## APPLICATION FOR SUBMITTAL OF POST-APPROVAL DOCUMENT

**ADDENDUM NO. 1**  
**PROJECT MANUAL**  
**MLK ELEMENTARY SCHOOL**  
**PARENT CENTER**  
**BAKERSFIELD CITY SCHOOL DISTRICT**

**Project No.: 5528**  
**DSA File No. 15-6**  
**DSA App No. 03-122604**  
**December 19, 2024**

Job No.: **5528**  
Sheet No.: **A2.10**

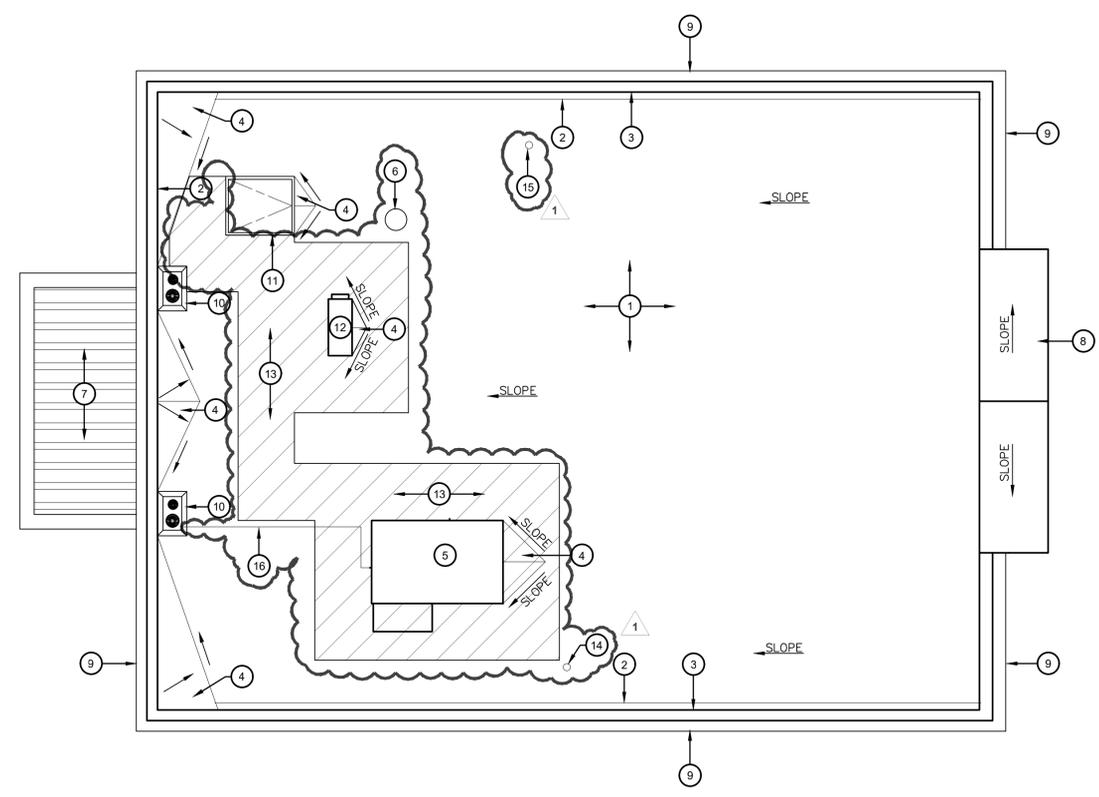
- 1-15 **DRAWING, SHEET A2.10 – FLOOR PLAN:** Note the following changes (See addendum 1 drawing):

1. Dimensions for pilasters and columns have been changed.
2. Electrical and low voltage panels in room 103 have been changed. See keynotes 21, 22, 24, 25 and 26 and Interior Elevations 3/A5.10
3. Add IDF cabinet to room 101. See keynote 20.
4. Add cabinets to room 101. See keynote 19.
5. Add mag lock pad at doors 101A and 101B. See keynote 28.
6. Add walk off carpet tiles to room 101. See keynote 27.
7. Add security keypad next to door 101A. See keynote 23.
8. Change markerboards to 4'-0" long. See keynote 2.
9. Keynotes 7, 8 and 12 have been modified.

Sheet No.:  
**A4.10**

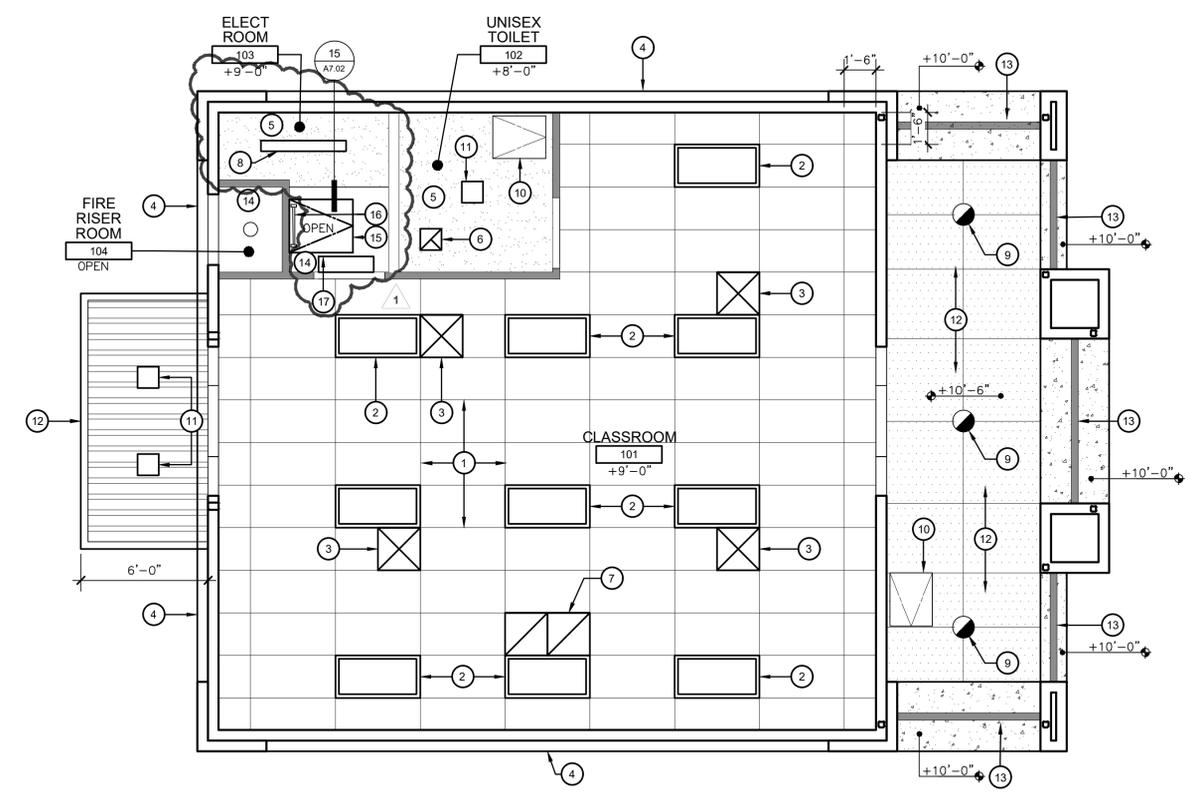
**1-16 DRAWING, SHEET A4.10 – ROOF PLAN:** Note the following changes (See A4.10 addendum 1 drawings):

1. Revise key note 6.
2. Add outdoor unit. See keynote 12.
3. Add roof walk mats. See keynote 13
4. Add hose bibb. See keynote 14.
5. Add roof vent penetrations. See keynote 15.
6. Add condensate pipe. See keynote 16.

Sheet No.:  
**A6.10**

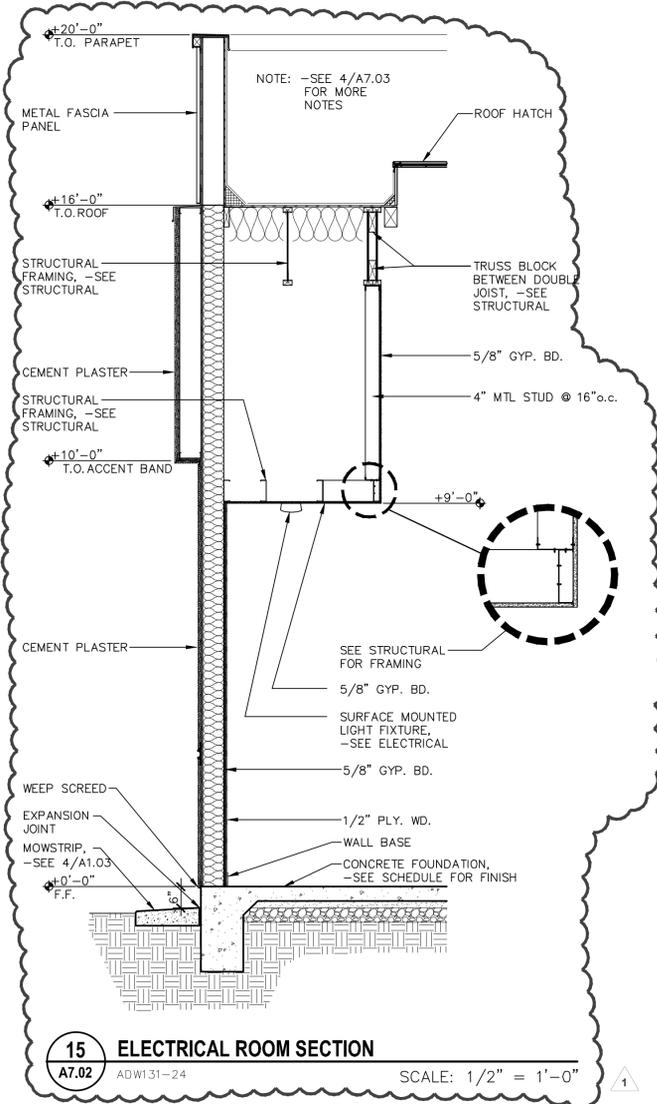
**1-18 DRAWING, SHEET A6.10 – REFLECTED CEILING PLAN:** Note the following changes (See A6.10 addendum 1 drawing):

1. Modify keynote 8
2. Add indoor air unit to room 103. See keynote 17.
3. Add 4x surface mounted light fixture to the legend.

**15 ELECTRICAL ROOM SECTION**  
A7.02 ADW131-24 SCALE: 1/2" = 1'-0"

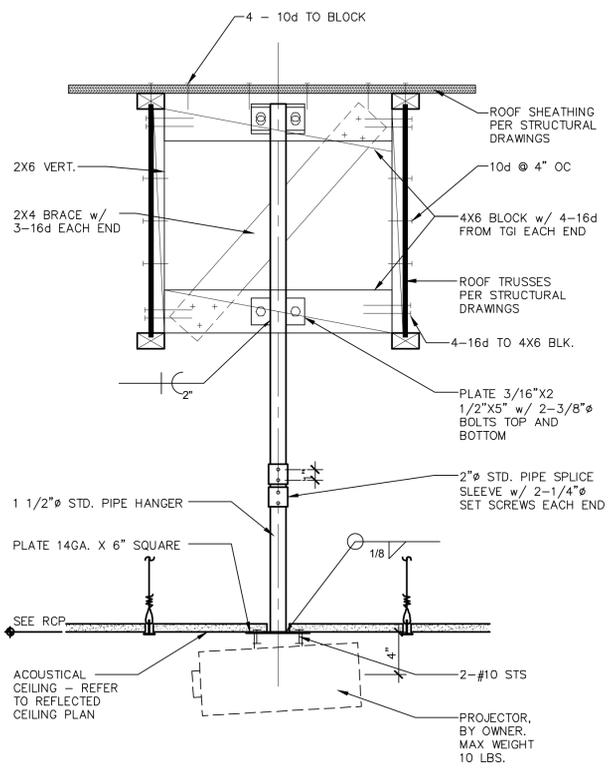
1. Replace roof drain details 2/A7.02 and 3/A7.02.
2. Add pipe penetration detail 6/A7.02
3. Add electrical room section detail 15/A7.02.

Sheet No.:  
**A7.03**

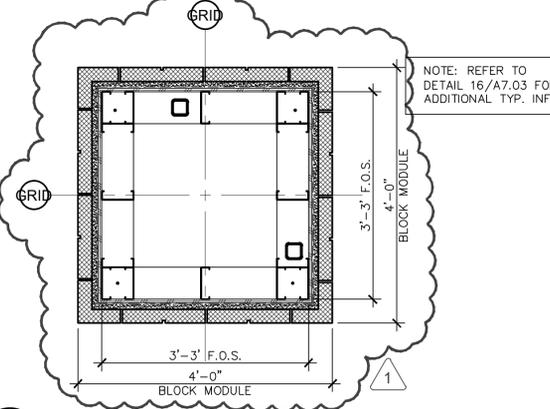
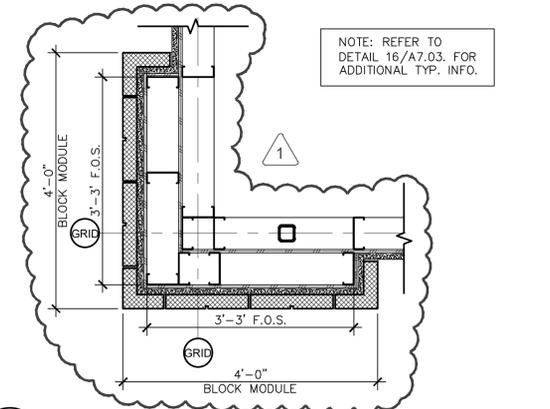
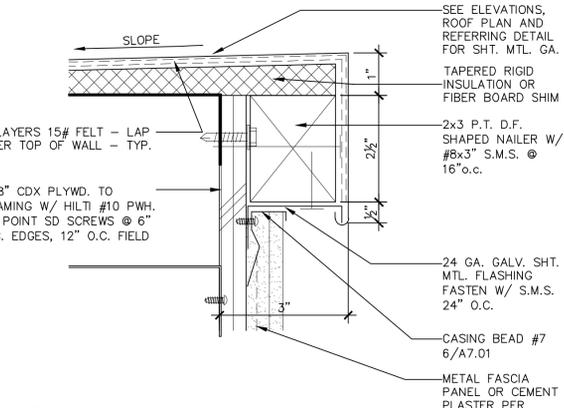
1. Details 10, 11 and 12 have new dimensions and show correct locations of the steel columns.

Sheet No.:  
**S2.01**

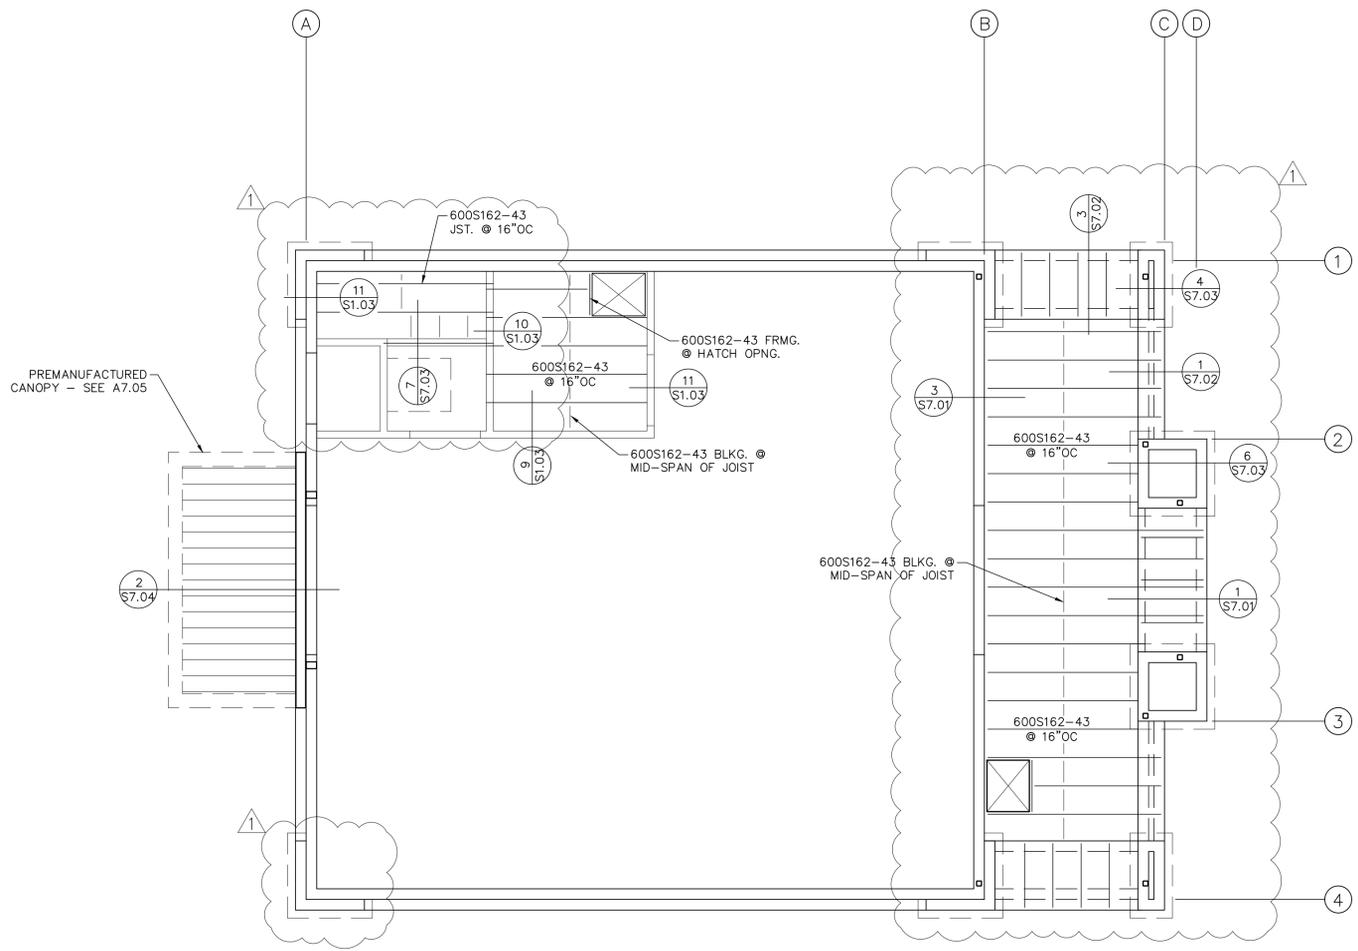
**1-21 DRAWING, SHEET S2.01 – FOUNDATION PLAN:** Note the following changes (See S2.01 addendum 1 drawing):

1. Dimensions for columns and pilasters have been changed.
- 1-22 DRAWING, SHEET S3.01 – CEILING FRAMING PLAN:** Note the following changes (See S3.01 addendum 1 drawing):

Holdowns are removed from the original plan. Provide calculations to justify.	Kyojin Ki...	S2.01 FOUN...
Holdowns replaced. see original calcs and new calcs.	Sean Par...	S2.01 FOUN...

Sheet No.:  
**S3.01**

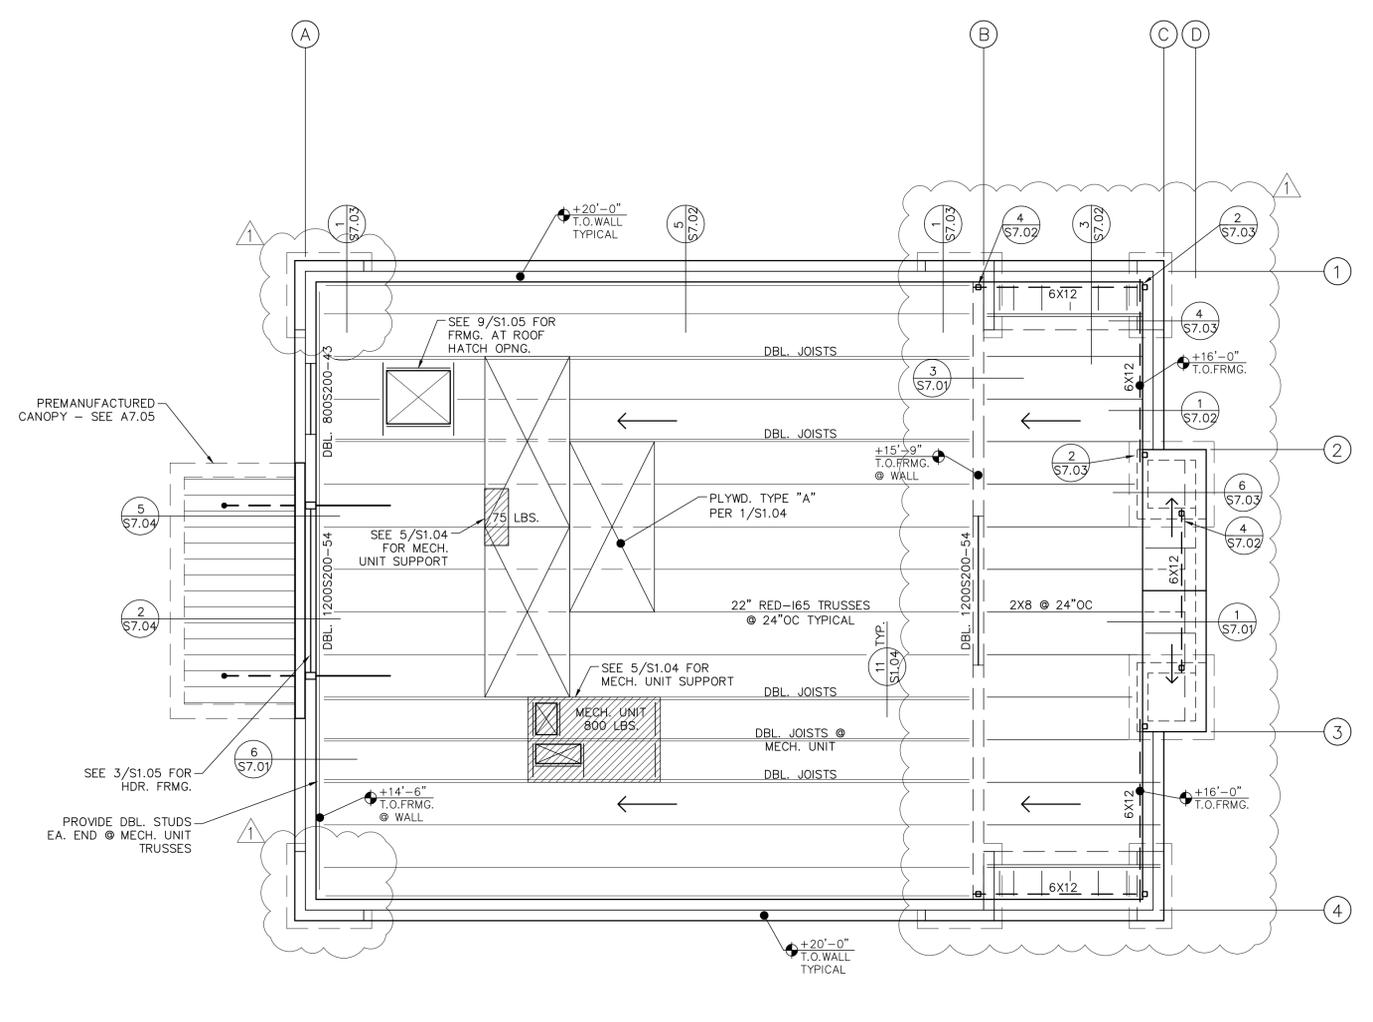
1. Add ceiling framing to electrical room.
  2. Add attic access door framing at covered walkway.
- 1-23 DRAWING, SHEET S4.01 – ROOF FRAMING PLAN:** Note the following changes (See S4.01 addendum 1 drawing):

Sheet No.:  
**S6.01**

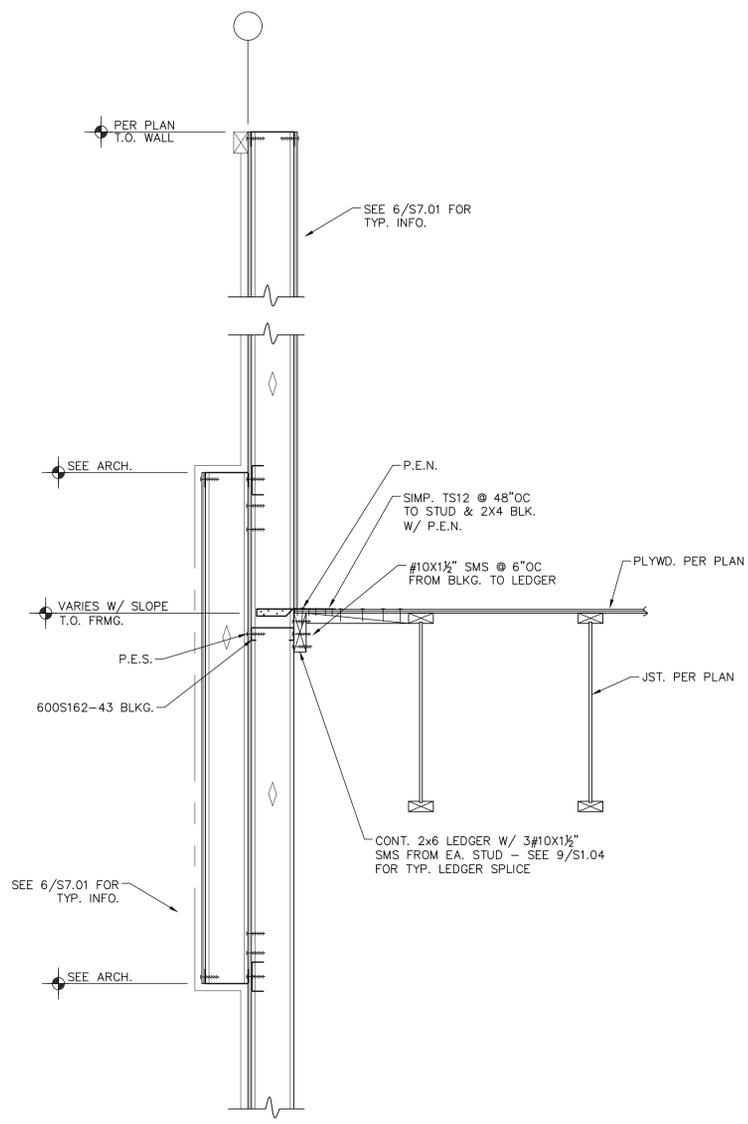
1. Details 3 and 6 the column pocket depth has been changed to 6”.
  2. Detail 9 concrete ledge has been added for the block veneer.
- 1-25 DRAWING, SHEET S7.02 – FRAMING DETAILS:** Note the following changes (See S7.02 addendum 1 drawing):

DETAIL SCALE: 1"=1'-0" (S7.02) 1

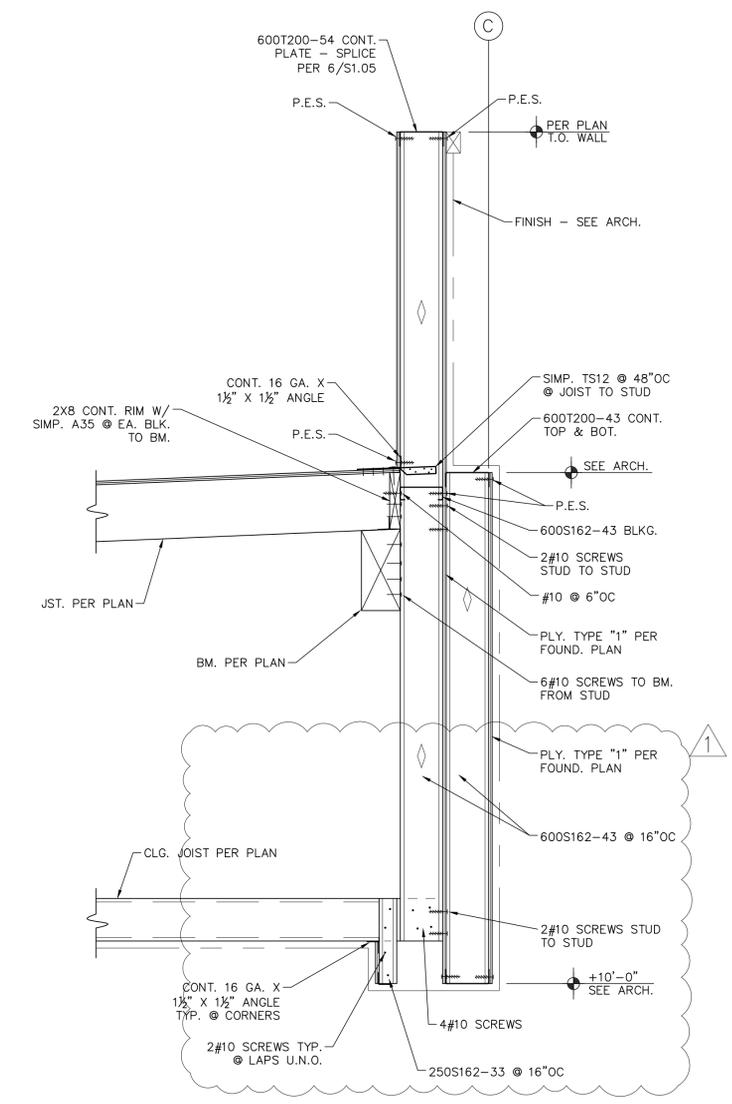
1. Detail 2/S7.02 has been deleted.
  2. Detail 1/S7.02 has been modified
- 1-26 DRAWING, SHEET S7.03 – FRAMING DETAILS:** Note the following changes (See detail S7.03 addendum 1 drawings):

Sheet No.:  
**M2.11**

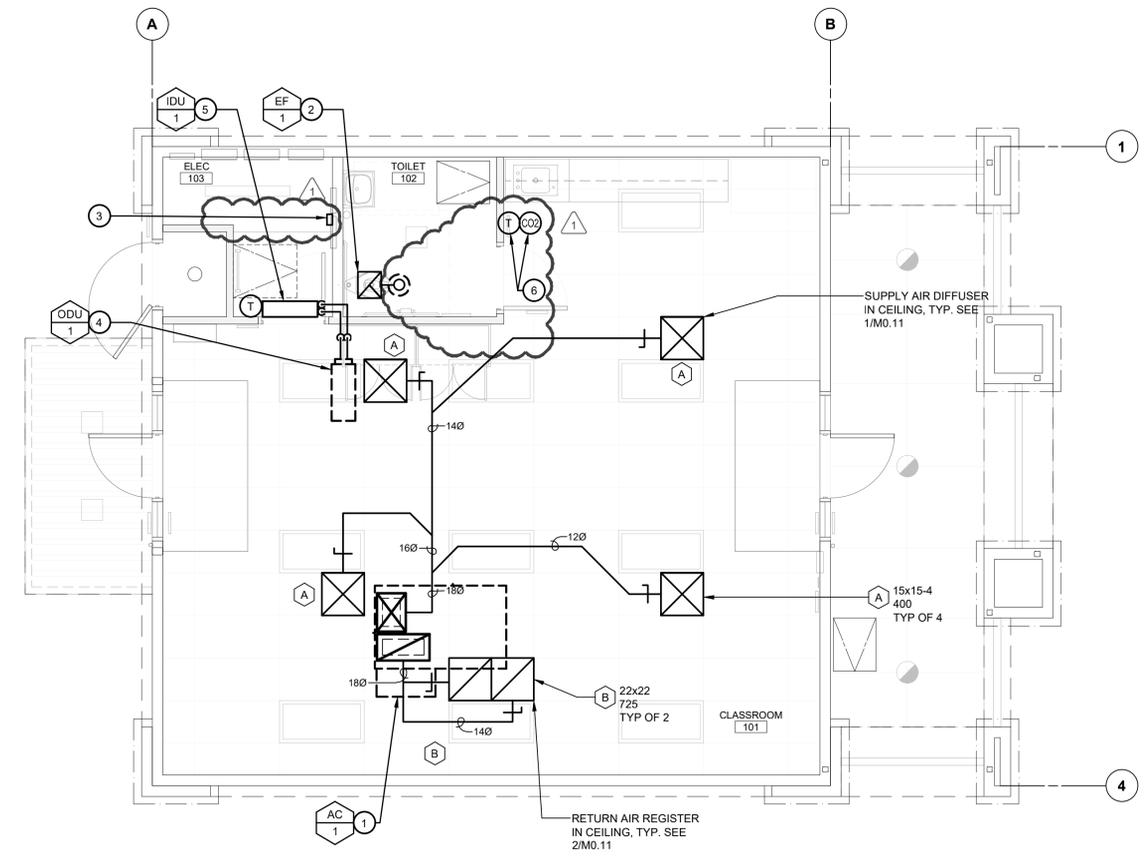
- 1-27 DRAWING, SHEET M0.01 – GENERAL NOTES-LEGEND:** Note the following changes (See M0.01 addendum 1 drawing):
1. Add OFCI “Owner Furnished Contractor Installed” to schedules
- 1-28 DRAWING, SHEET M0.11 – DETAILS:** Note the following changes (See M0.11 addendum 1 drawing):
1. Add detail 8 and 13.M0.11 in their entirety.
- 1-29 DRAWING, SHEET M2.11 – HVAC PLAN:** Note the following changes (See M2.11 Addendum 1 drawing):
1. Change location of wireless repeater in room 103. See keynote 3.
  2. Change locations of thermostat and CO2 detector. See keynote 6.
  3. Keynotes 1, 2, 4, 5, and 6 have been modified.
